**Comments by Clark County, Nevada**

**U.S. Department of Energy's Draft Environmental Impact Statement for a Geologic Repository for the Disposal of Spent Nuclear Fuel and High-Level Radioactive Waste at Yucca Mountain, Nye County, Nevada**

*Prepared by*  
*Clark County Department of Comprehensive Planning*  
*Nuclear Waste Division*  
25 February 2000

Figure E-3 Illustration of Results of Modeling of the Near Field Geochemical Environment  
(Source: DOE 1998a, Volume 3)

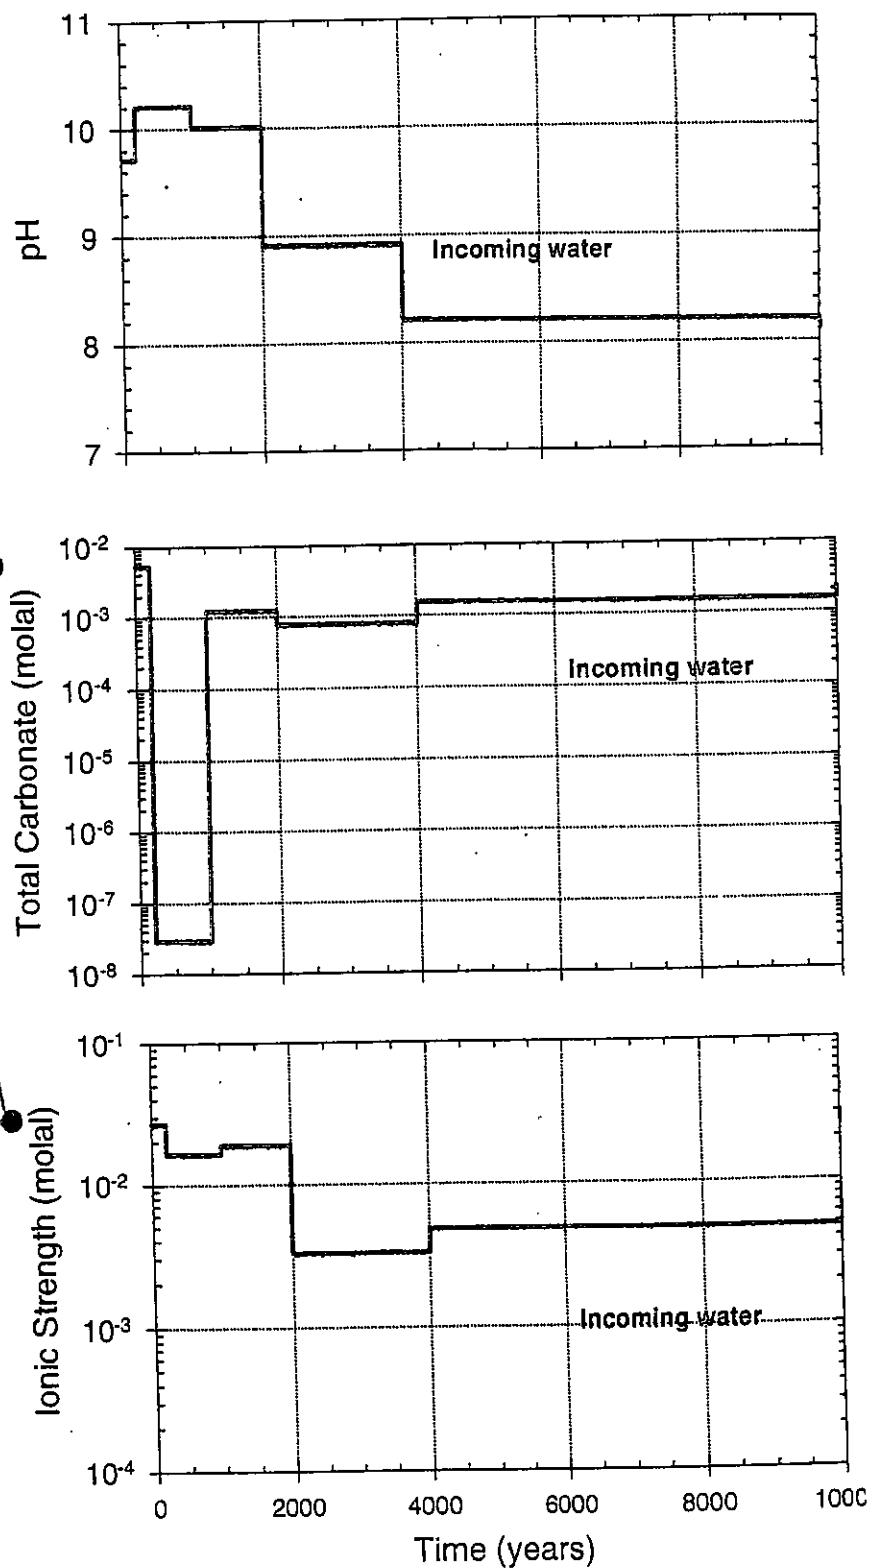
Uncertainties or deficiencies in the existing data base essentially constitute a baseline for uncertainties in parameter values associated with evolution of the NFGE. As illustrated by Figure E-3, the variation of parameter values with time that emerges from the modeling approach in which coupled phenomena are uncoupled and steady-state is assumed for sequential time periods is extremely complex. The TSPA-VA dealt with these variations in a process in which values such as those shown in Figure E-3 were treated as deterministic values, alternative conceptual pathways for evolution of the NFGE were considered, and standard deviations were assigned to the calculated expected values for the pathways. This approach produced results such as those shown in Figure E-4. In Figure E-4, the probability distribution functions are shown at the end of the period of their applicability to the system, e.g., the distribution shown for 100,000 years applies to the period from 10,000 to 100,000 years.

Figure E-5. NFGE Model Connections to Produce Parameter Values (Source: DOE 1998b)

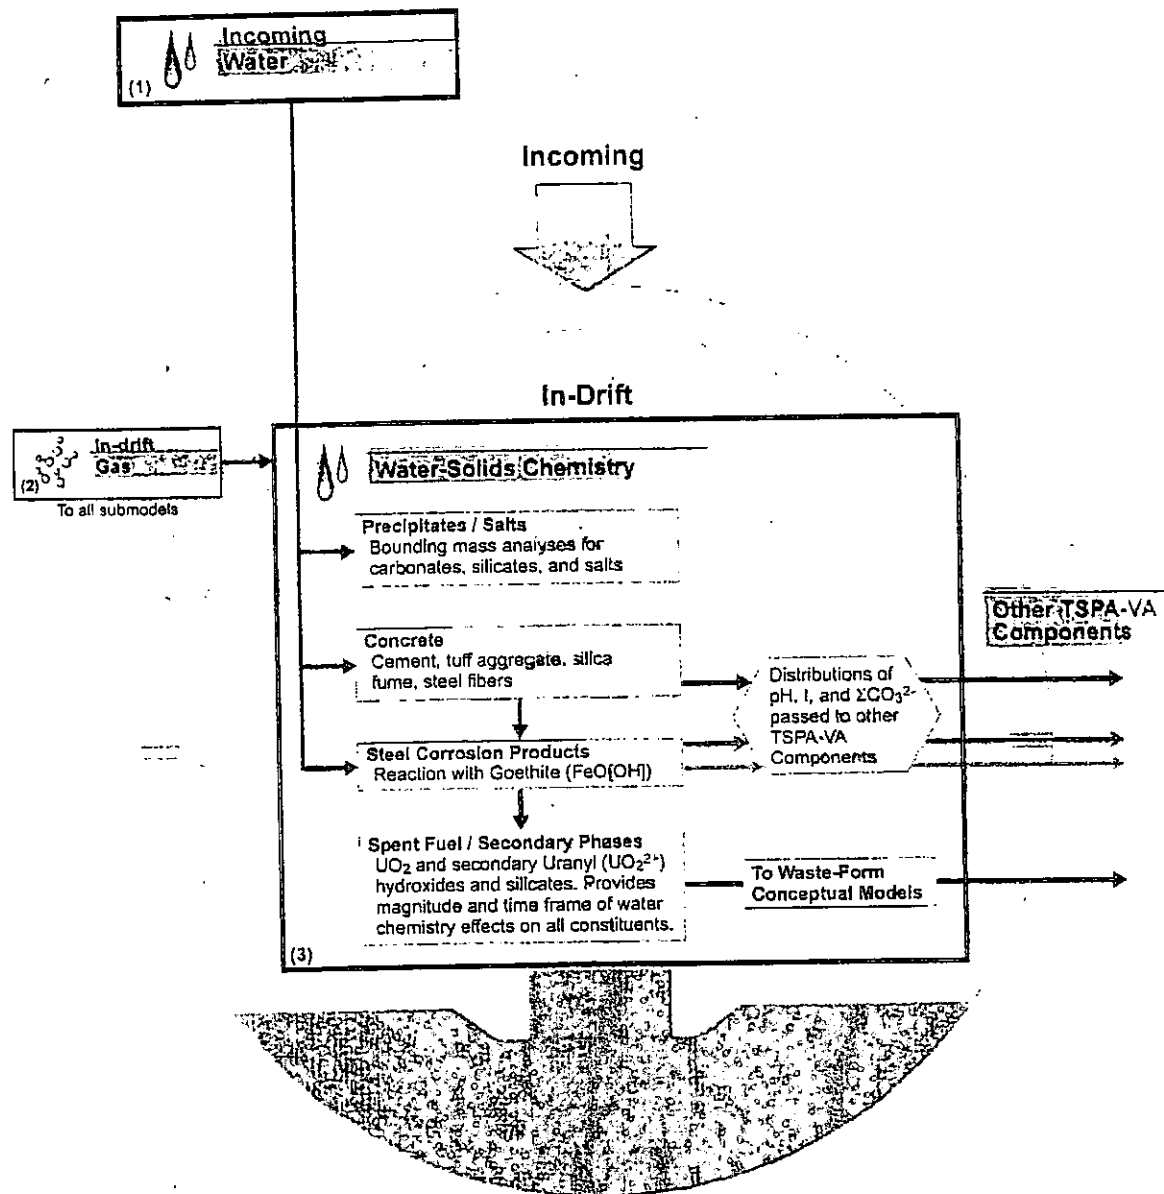
The TSPA-VA modeling approach for the NFGE which would lead to waste package and waste form degradation rates is shown in Figure E-5. Parallel paths of reaction of incoming water with steel corrosion products and with concrete are shown to establish the chemistry parameters which become the basis for performance parameters such as waste package corrosion rates. In the TSPA-VA base case, the concrete path was not used because it was assumed that the concrete liner would collapse during the 500 to 10,000 year period, and water would therefore drip directly onto the waste packages. The concrete path was investigated in sensitivity studies, which concluded that the high pH water established by reaction of incoming water would greatly accelerate waste package failure rates. This effect was not, however, part of the base case, and it may be that the assumed effect of high pH water on the corrosion rate of the corrosion-resistant material was excessively conservative.

**Figure 1 Past SNF Truck Shipment Miles and Proposed Shipment Miles**

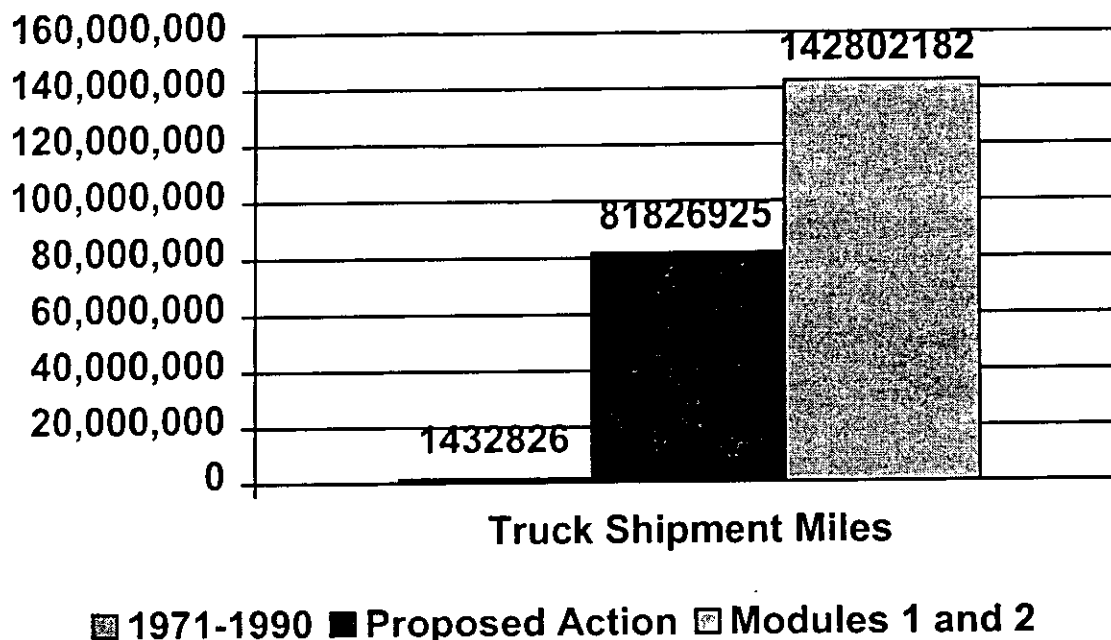
Figure 1 compares the shipment-miles for spent fuel in the 1971-1990 period to the shipment miles for the Proposed Action and Modules 1 and 2. Clark County believes the great disparity in numbers suggests that any reliance on previous history is extremely problematic.

256 The greatest cause for concern is the absence of operational performance data for most of the complex packaging, handling and shipping equipment required to implement the Proposed Action and Modules 1 and 2. For example, the GA-9 transportation cask is one of the primary components of the waste handling system envisioned in the DEIS. However, that cask requires a special trailer to handle and transport. This trailer has not yet been constructed. As was noted in one of the reference documents supplied with the DEIS, only "preliminary sketches" exist. This problem is particularly acute for the heavy haul transportation proposal. No data are presented in the DEIS to support any conclusions about the safety of transporting a 125 ton cask twice daily at 25 mph on an urban bypass with posted speeds of 65mph through Clark County. No past experience, transporting spent fuel is relevant to the proposed action because there is no operational performance data for the equipment used to handle the waste.

**Figure 6 Population Growth in Clark County**

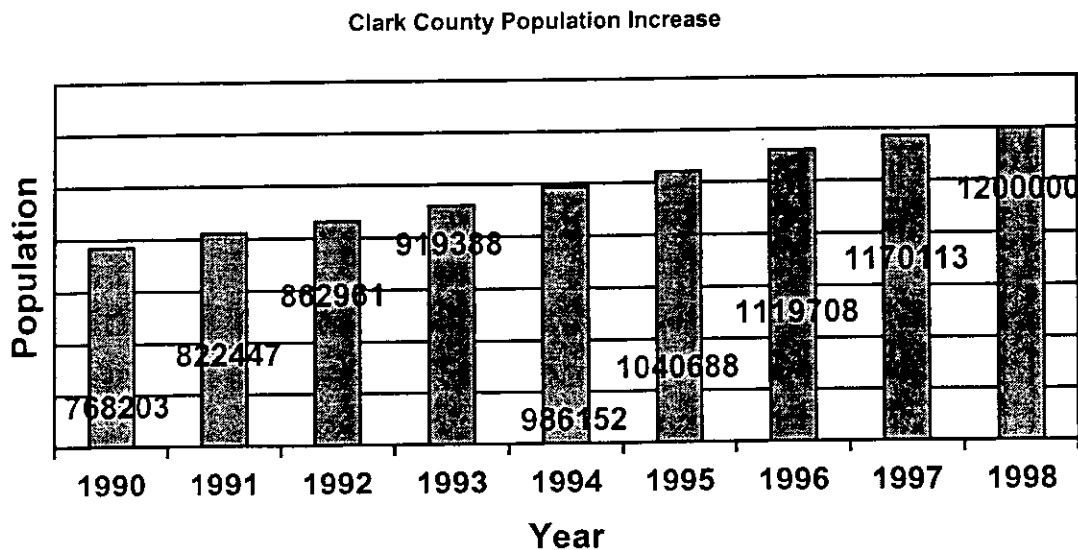
The DEIS defines the affected population as those Clark County residents living within .5 miles of the route. Unfortunately, the DEIS relies on 1990 census data, although data that is more current was available. The most current demographic information was readily available from a number of different sources in the county and should have been consulted by the DOE in preparing the estimates. This is an important issue because of Clark County's rapid population growth as shown in Figure 10:

**Figure 7 BLM land disposal boundaries in Clark County**

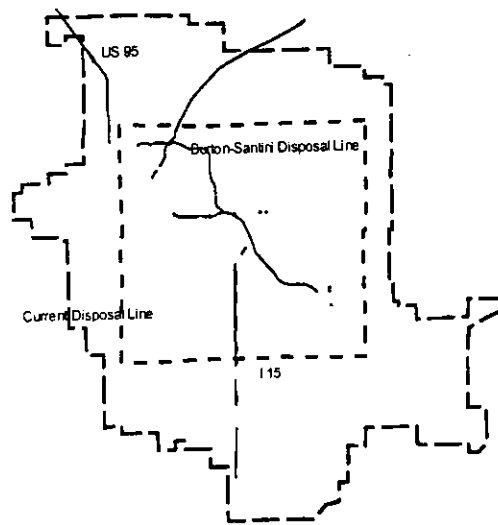
The valley in which urban Clark County rests is geographically constrained. That is, the physiographic features of the region force human activity to take place in certain areas rather than others. Future population growth in Clark County must take place along potential HLW transportation routes. Urban Clark County has outgrown its original bounds and one of the most contentious issues in the region is the disposal of land from the US Bureau of Land Management (BLM). The original boundaries for urban Clark County have been adjusted several times to account for this growth. The map in Figure 11 depicts these changes.

**Figure 8 Low Level Radioactive Waste Shipped to NTS**

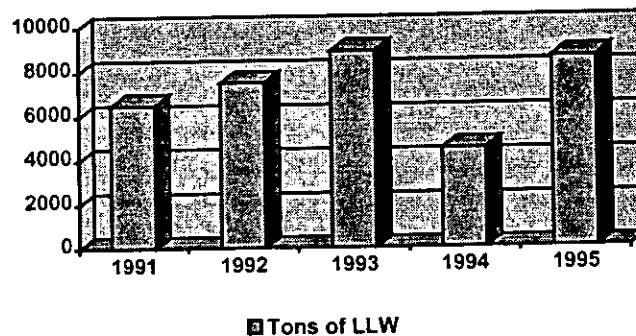
319 The cumulative effects portion of the DEIS understates the scale and complexity of the cumulative impacts of the DOE's waste disposal program. Despite assurances in the Waste Management Programmatic Environmental Impact Statement, the DEIS does not contain an authoritative examination of the cumulative impacts of both DOE disposal programs on Nevada and Clark County. According to some estimates, the shipment of Low Level Radioactive Waste from DOE defense sites across the nation to the Nevada test Site will last for approximately 70 years. The waste will be shipped by truck, and may be shipped through the most densely populated and sensitive parts of Clark County. The LLW shipping campaign will require up 12 trucks per day for the entire 70 years of the program. The chart in Figure 11 depicts the recent LLW shipments through Clark County to the Nevada Test Site.

320... The DOE has already established a poor record of accomplishment for managing and transporting LLW in Clark County. As indicated above, the DOE has transported at least five and possibly
